ADDENDUM NUMBER FOUR (4)

BASEBALL PAVILION REPAIRS
MISSISSIPPI VALLEY STATE UNIVERSITY
ITTA BENA, MISSISSIPPI

Addendum No. 4
Baseball Pavilion Repairs
Mississippi Valley State University
DDG Project No.: 20.012

SUP01

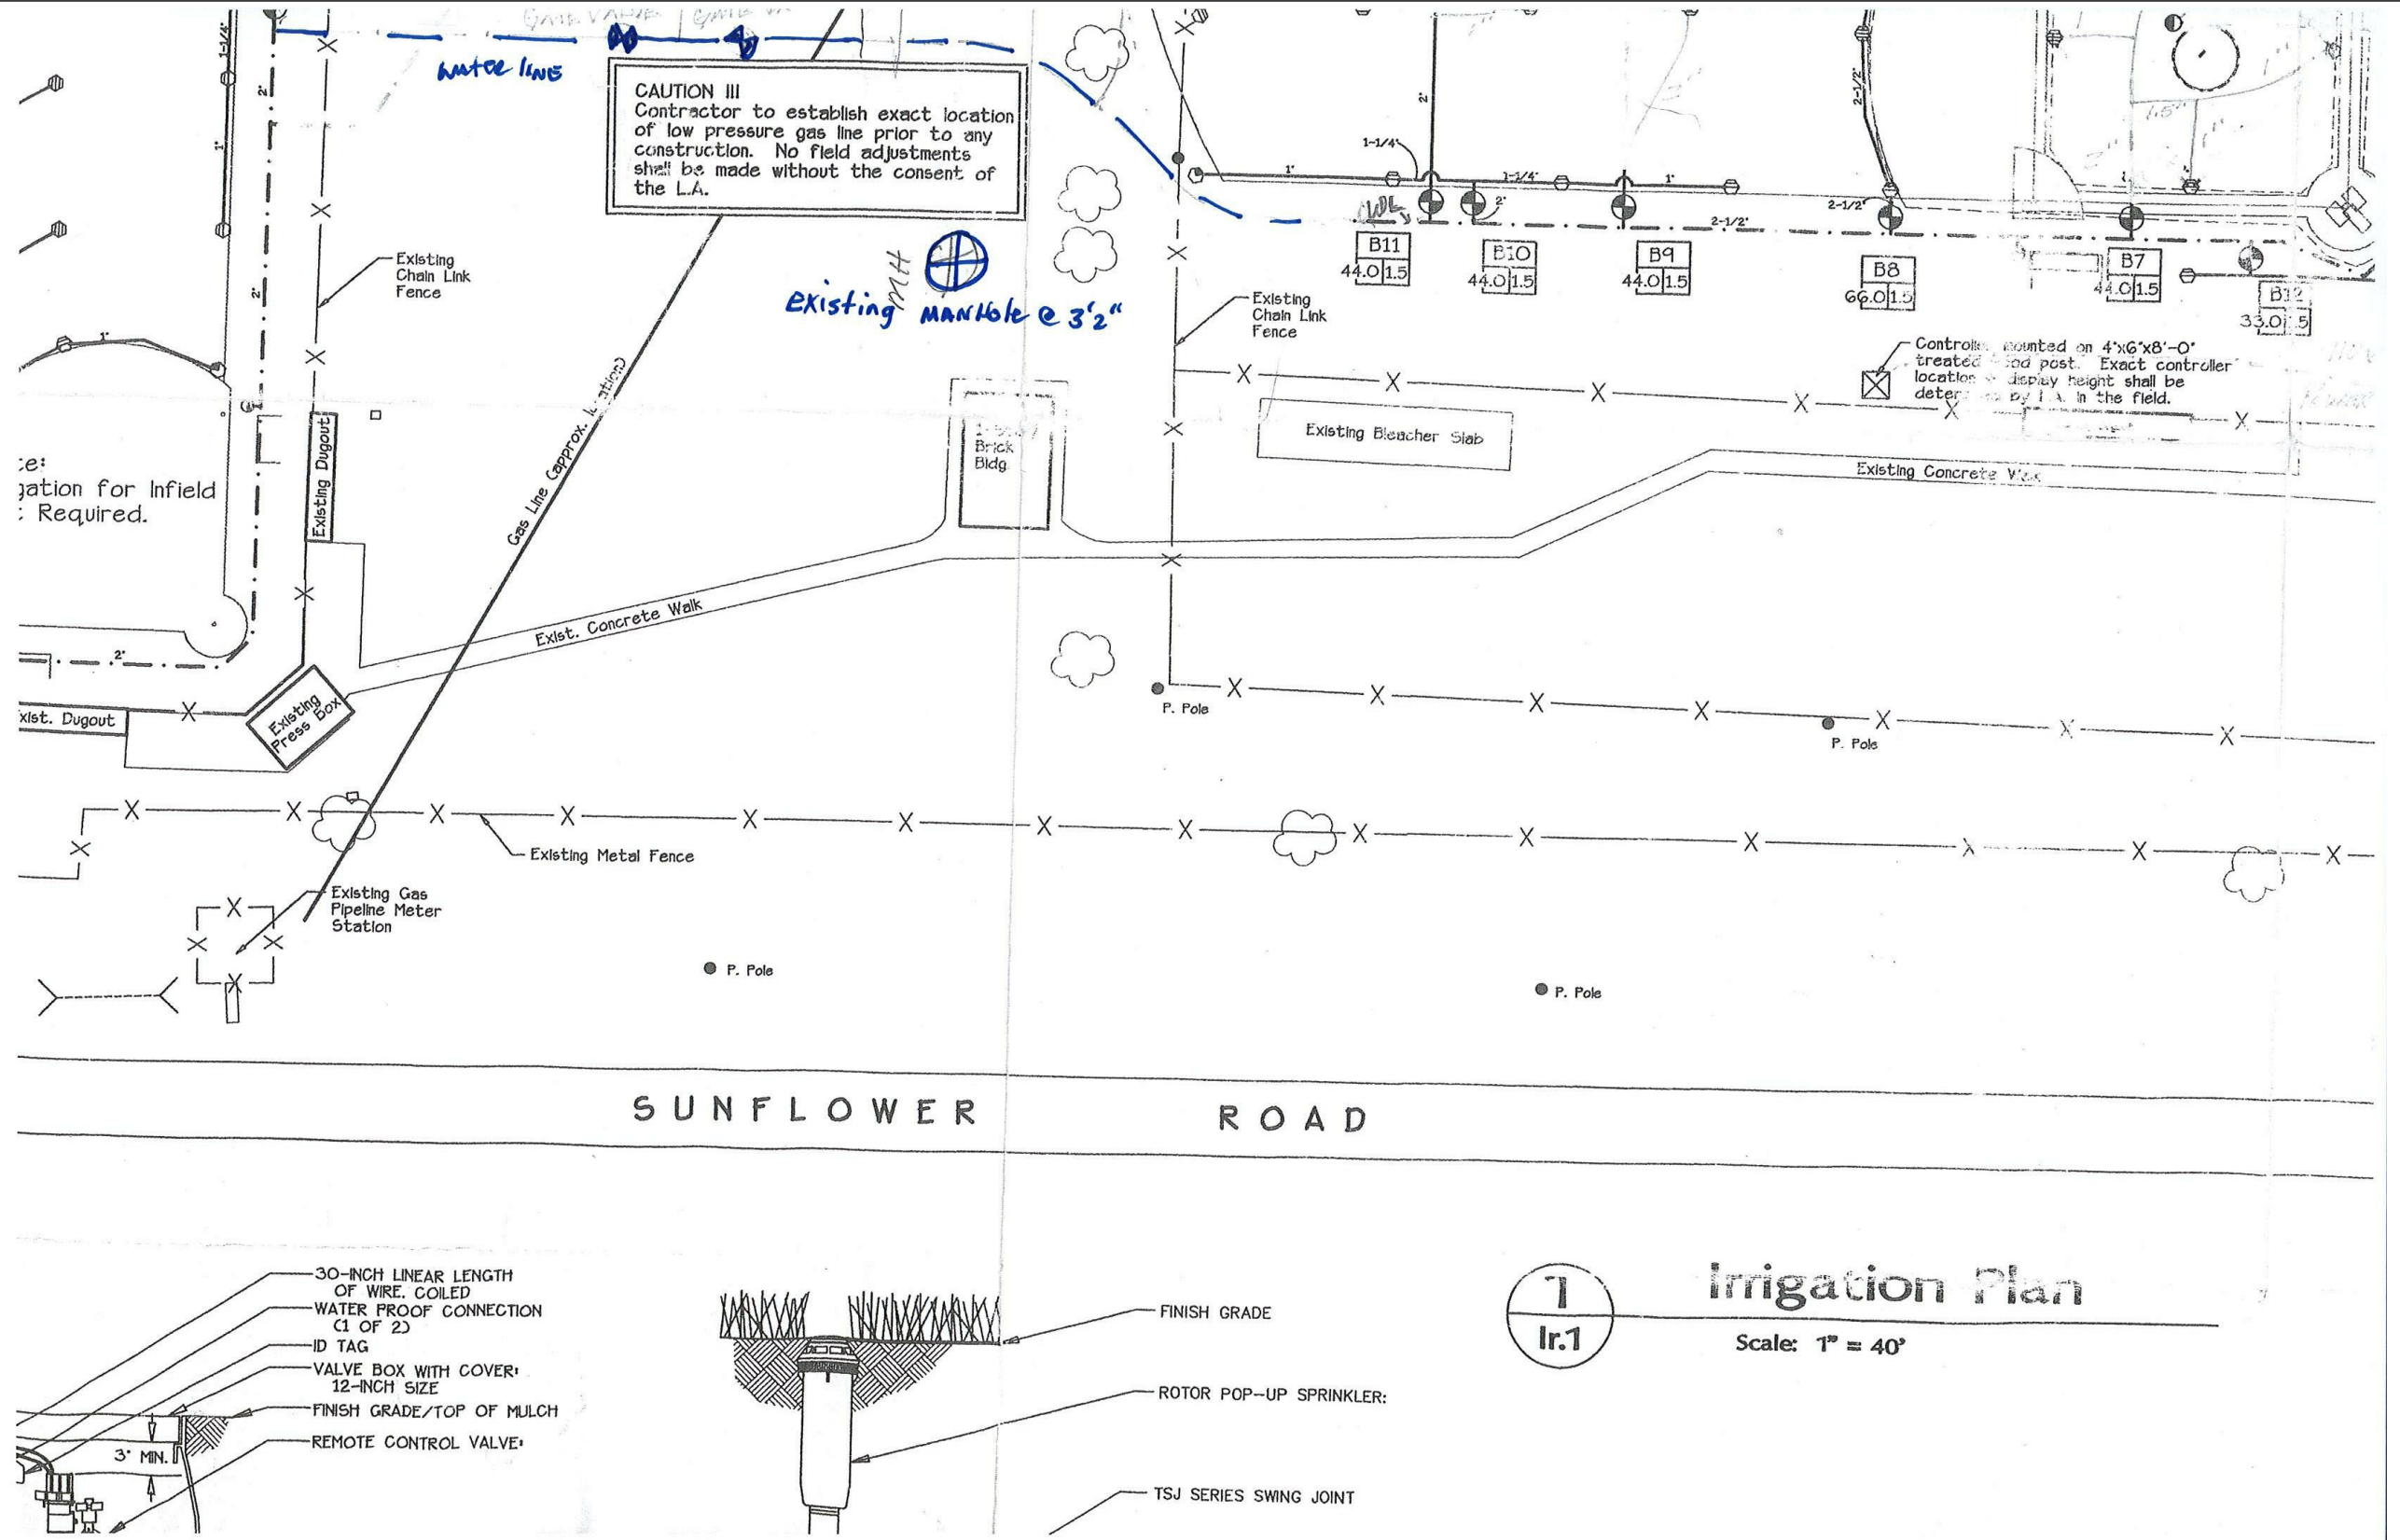
1. **DELETE** Vicinity Map and **REPLACE** with Attached SUP01 Vicinity Map.

SUP02

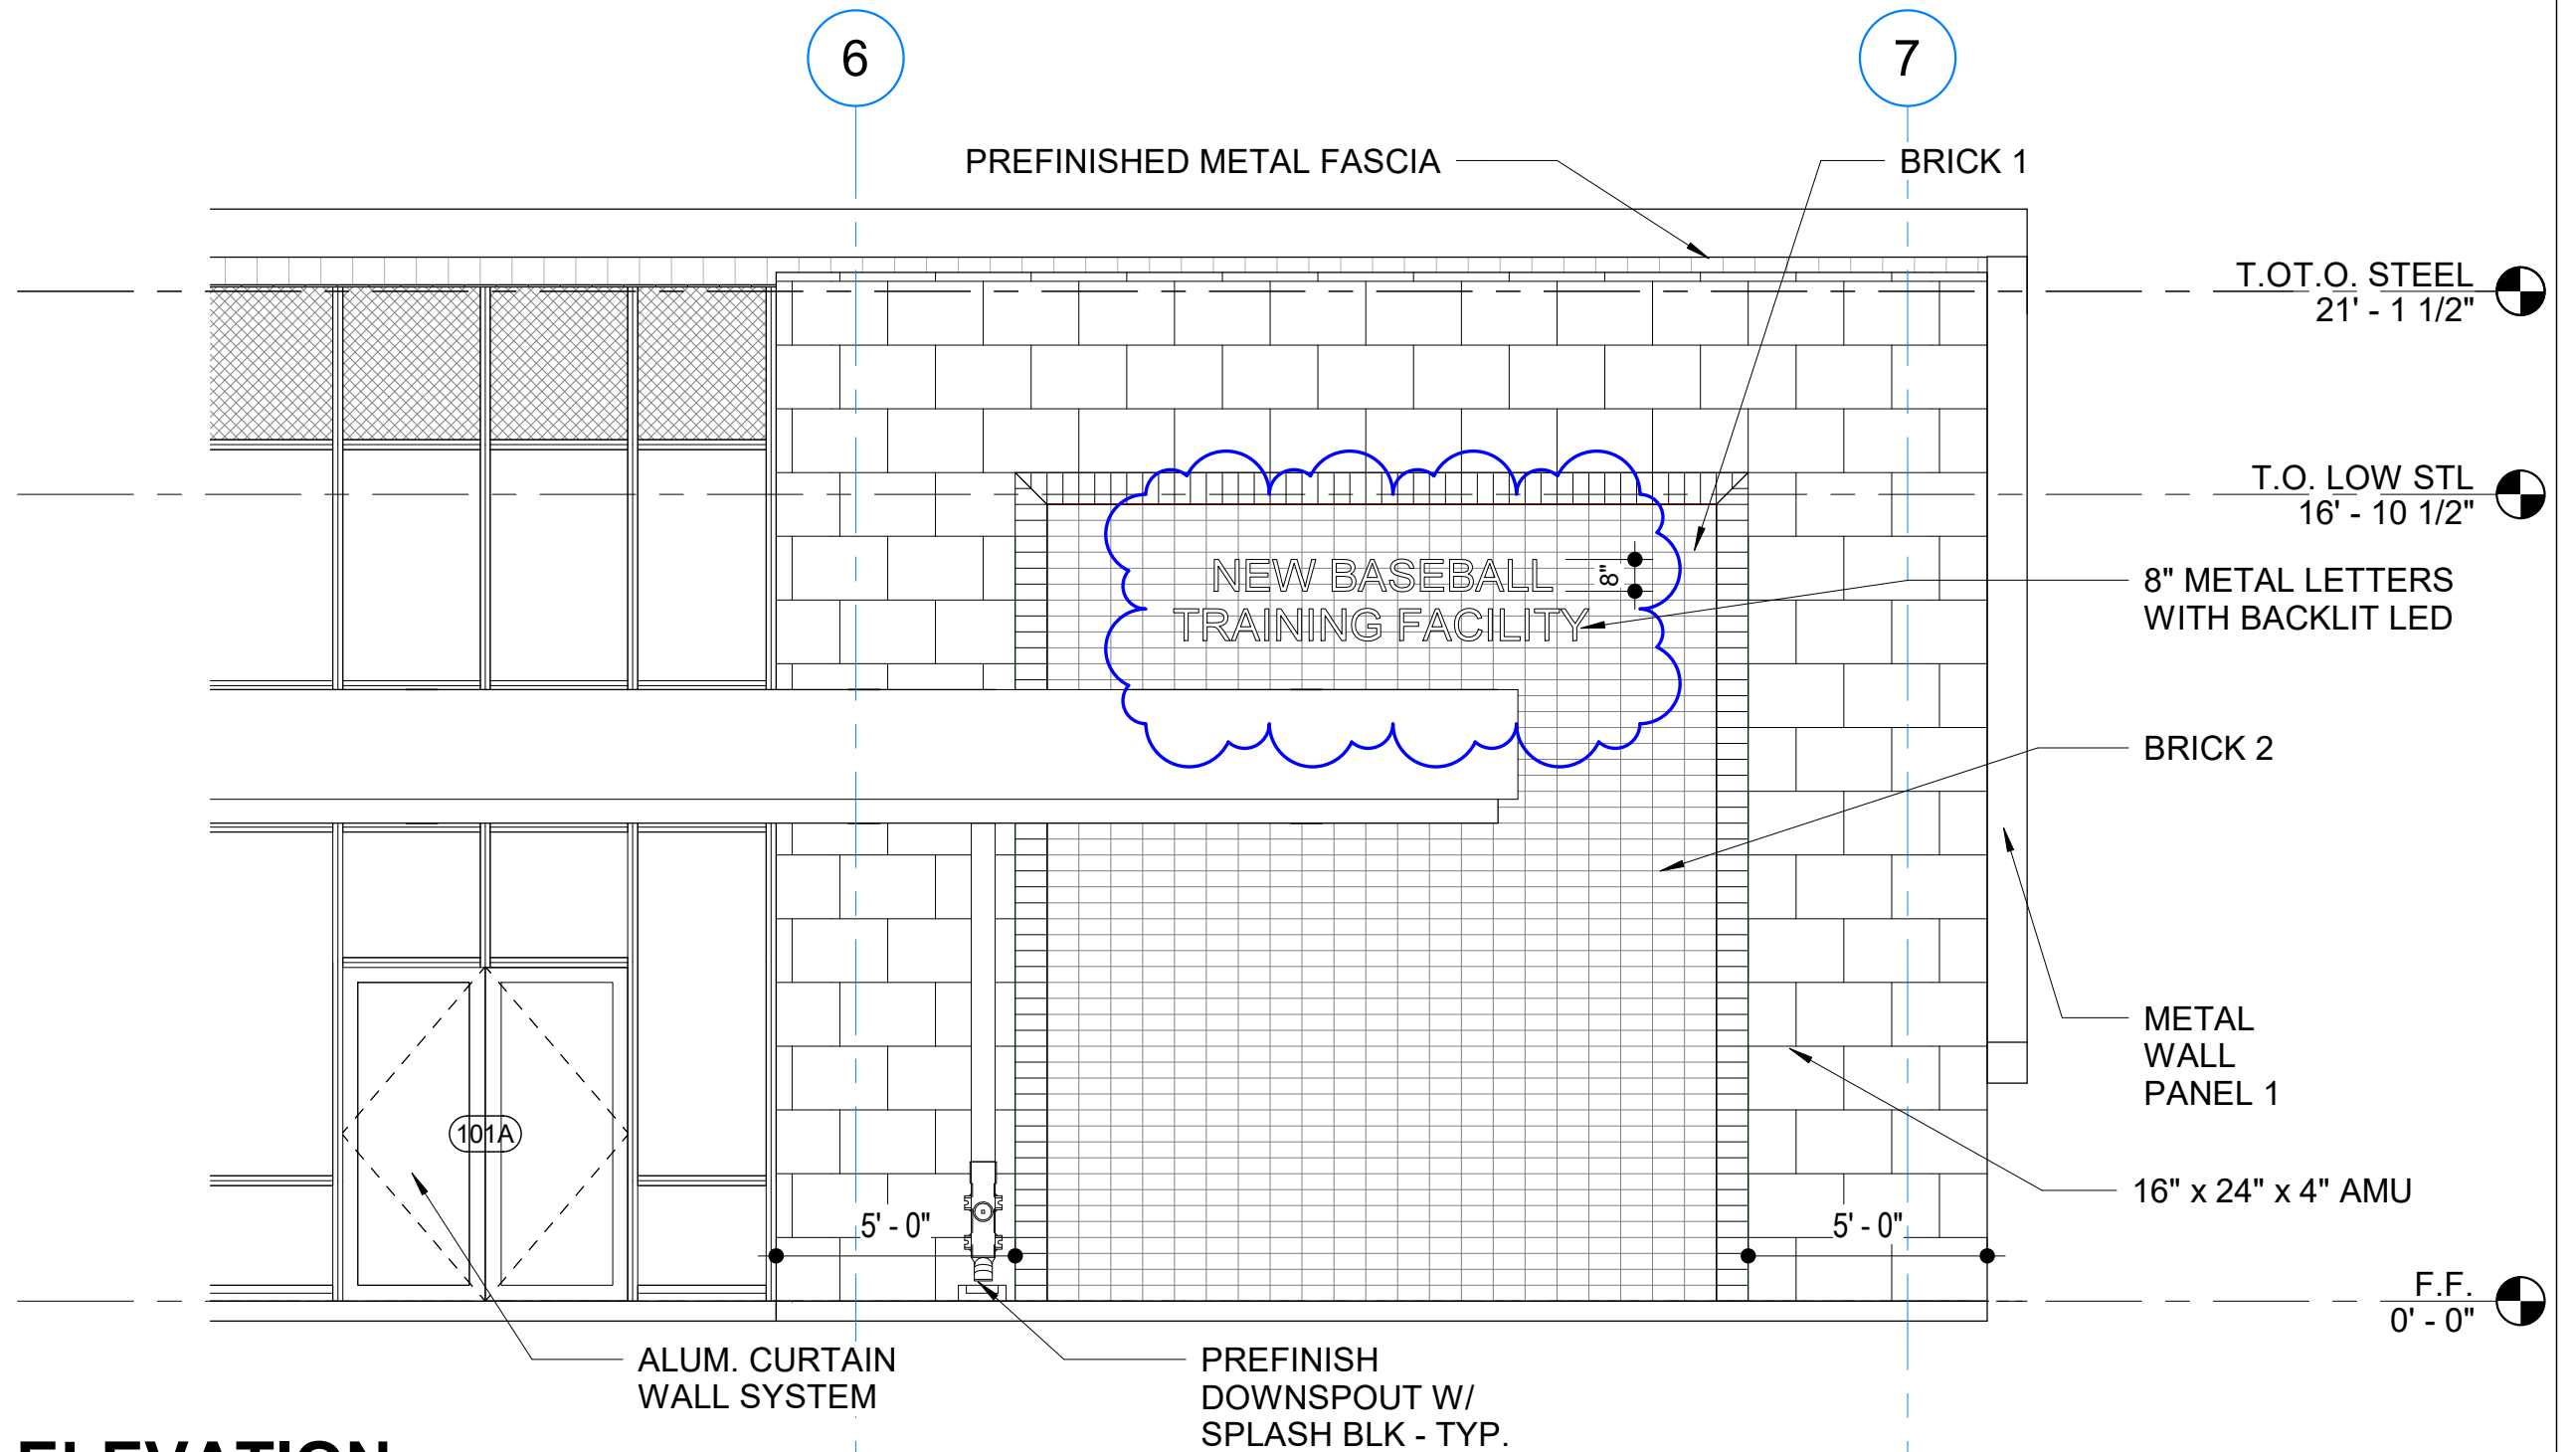
1. **ADD** Attached Section 32 31 13 Vinyl Coated Chain Link Fence
2. **ADD** to the Appendix the attached SUP02 Owner Presume Water and Sewer Locations.

1 PARTIAL ELEVATION

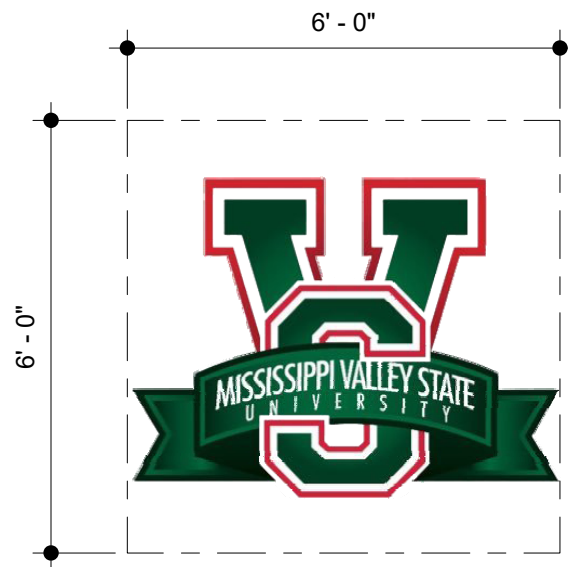
1. **ADD** Attached SUP03 information to Drawing 1/A201B.1.

1 FLOOR PLAN SCHEME B
SUP04 1/8" = 1'-0"

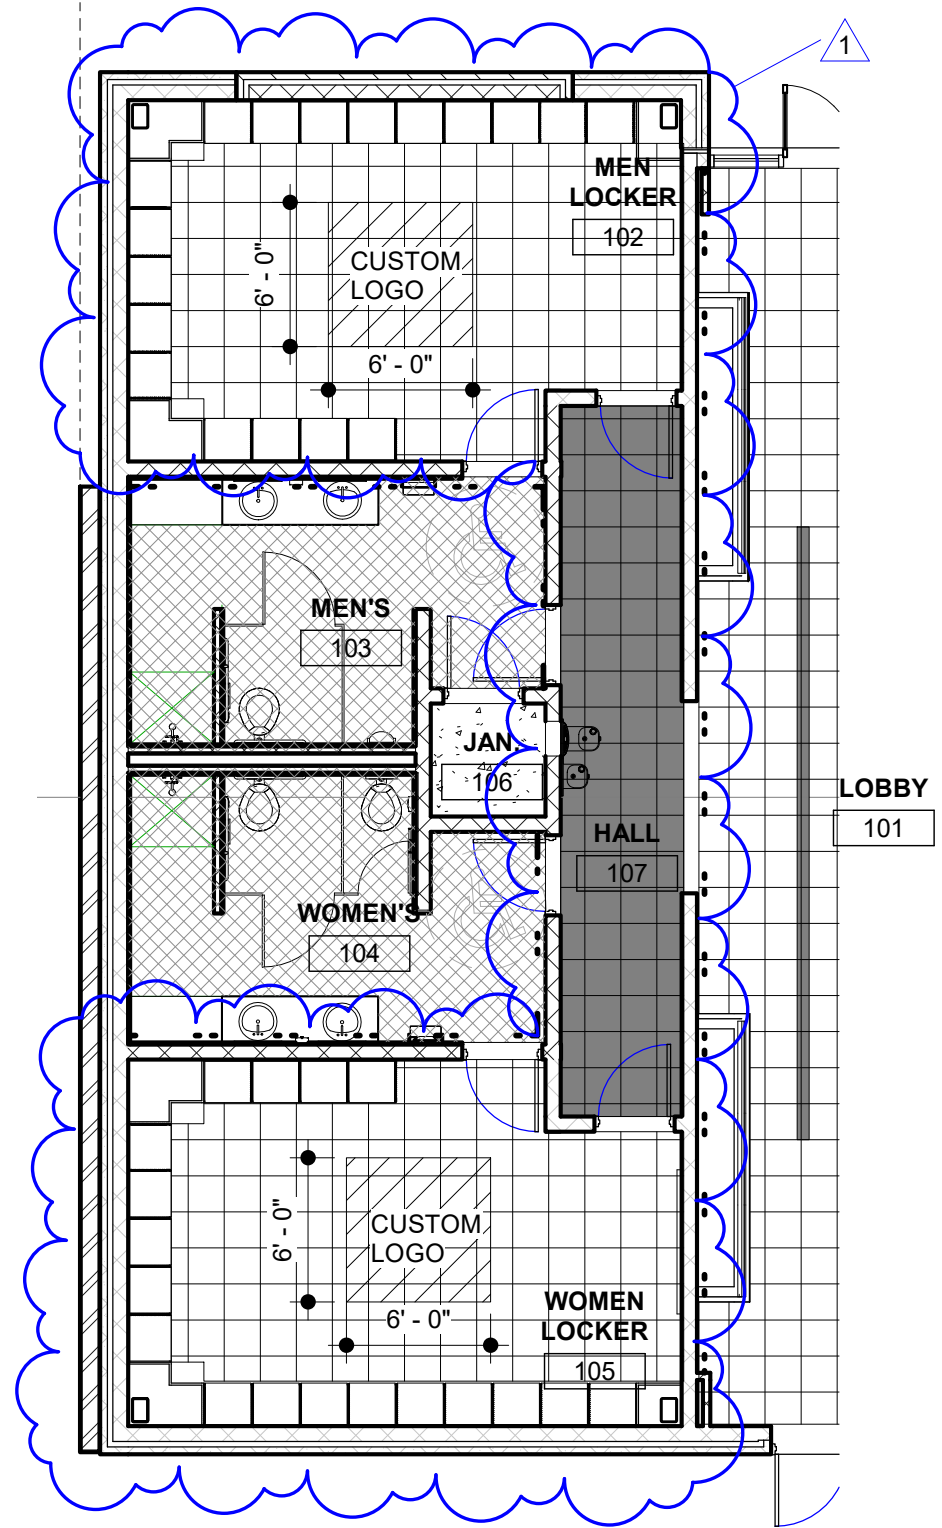
1. **ADD** Attached SUP04 information to Drawing 2/A701.

CUSTOM LVT MVSU LOGO - 4 COLORS
OVERALL SIZE WITH FIELD 6' X 6'

SUP05

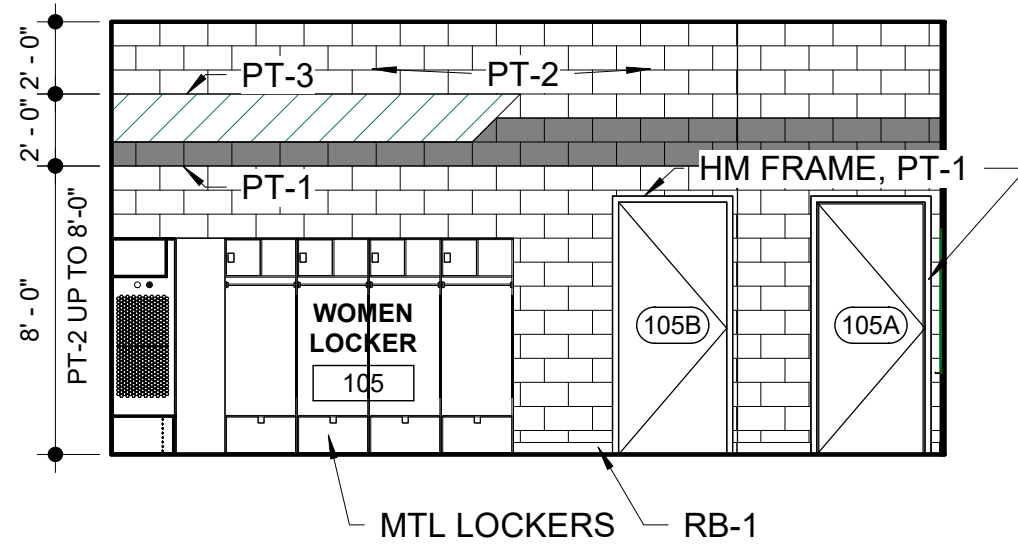
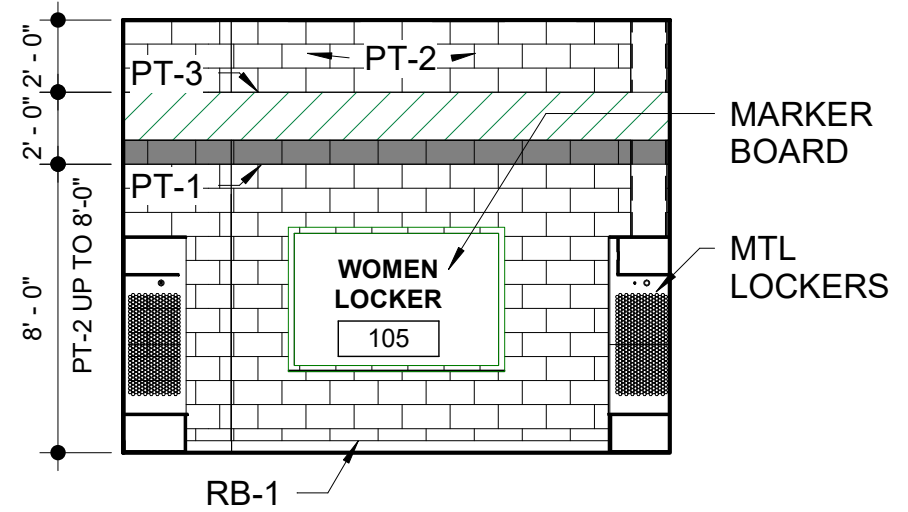
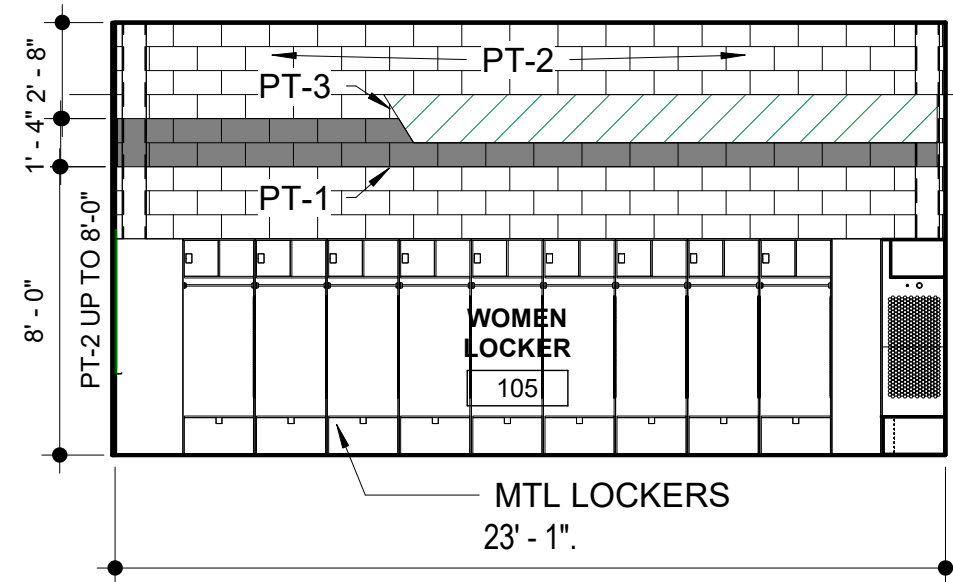
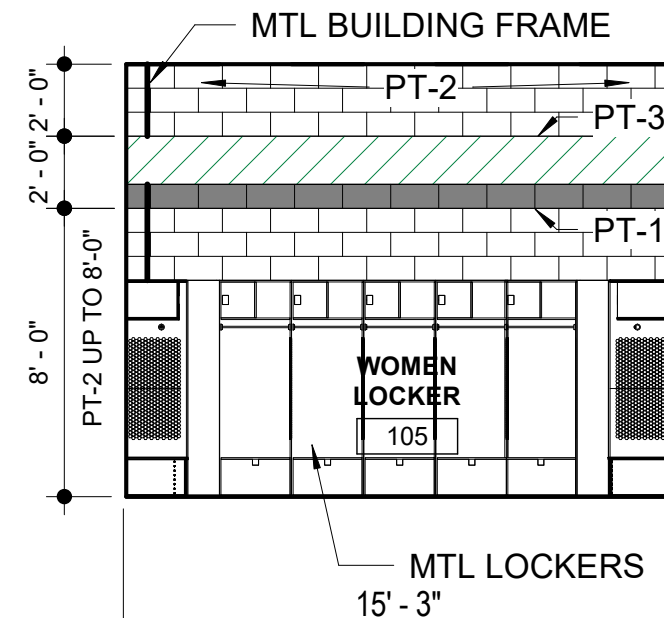
1. **DELETE** Drawing 3, 4, 6, AND 7 IN SHEETA702B and **REPLACE** with Attached SUP05.
2. **DELETE** Drawing 5 IN SHEETA702B and **REPLACE** with Attached SUP06.
